CITY OF MERCER ISLAND

DEVELOPMENT SERVICES GROUP

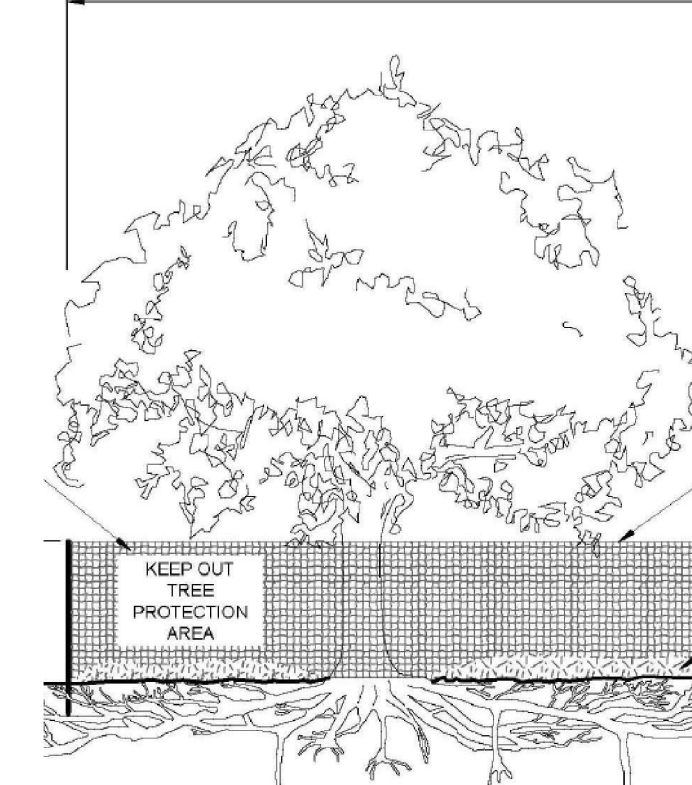
1. Correction Notices or Stop Work Orders until compliance is achieved
2. RE Inspection Fees/financial penalties
3. Arborist reports recommending mitigation

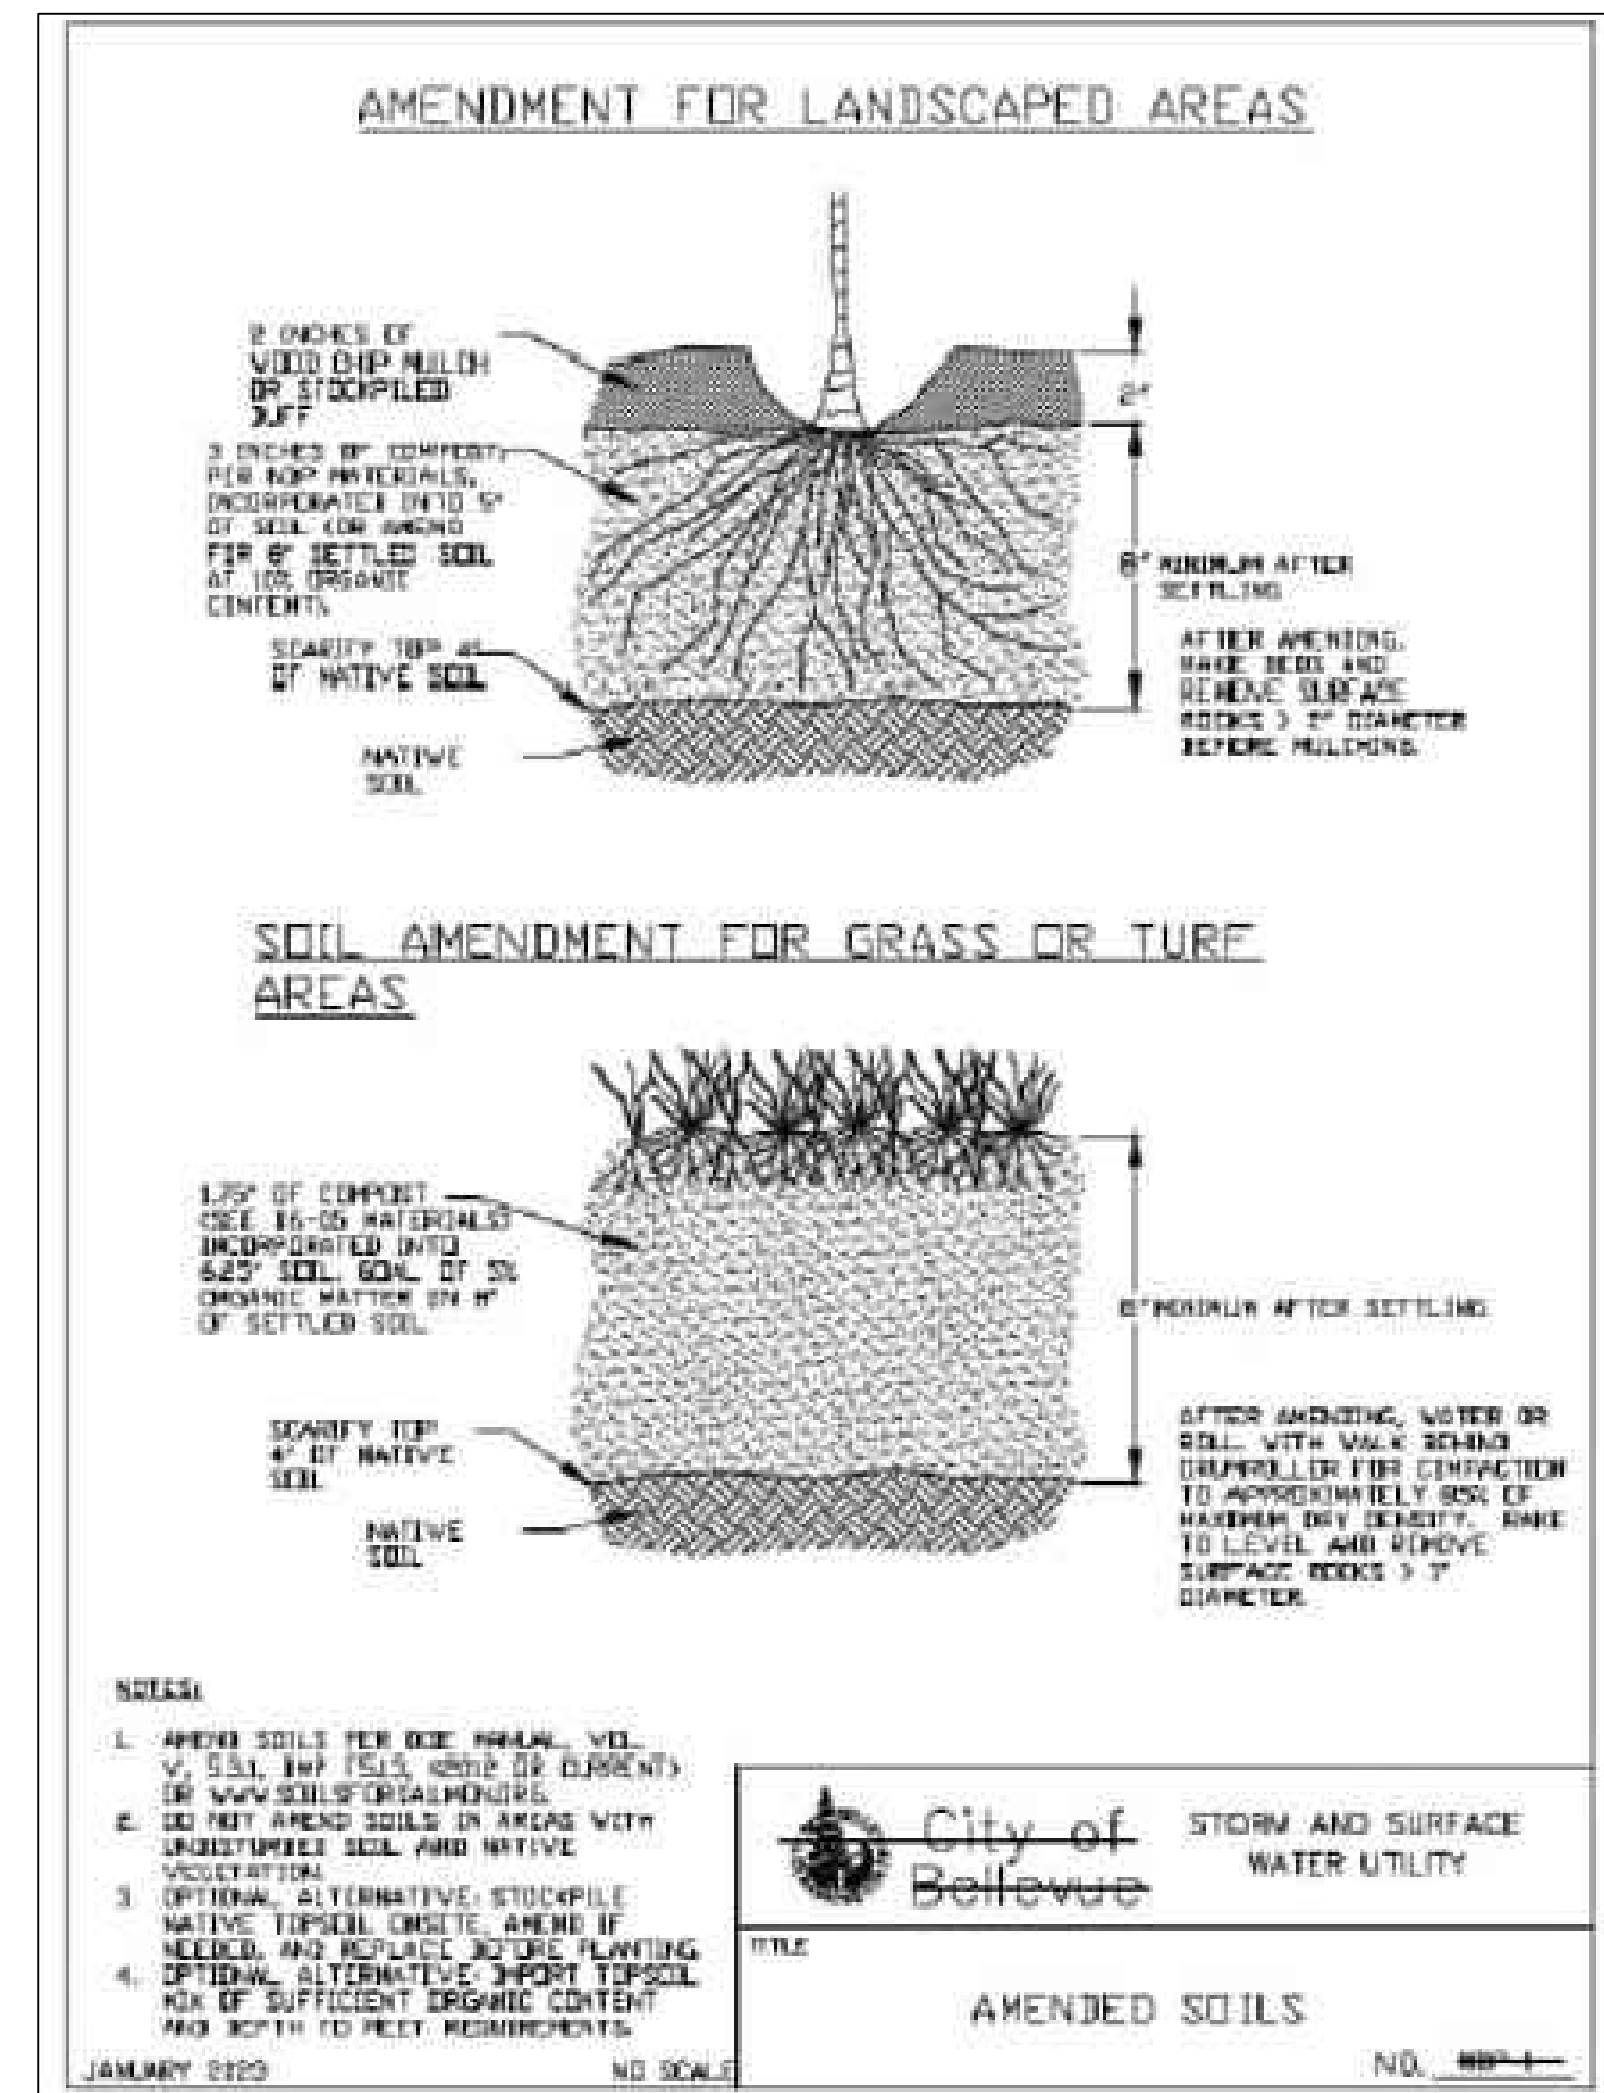
Checked: 12-28-23 PRELIMINARY PLAN
 1-4-26-24 REVISED TO ADD TREES AND SOIL REQUIREMENTS
 Director: REB
 GCA
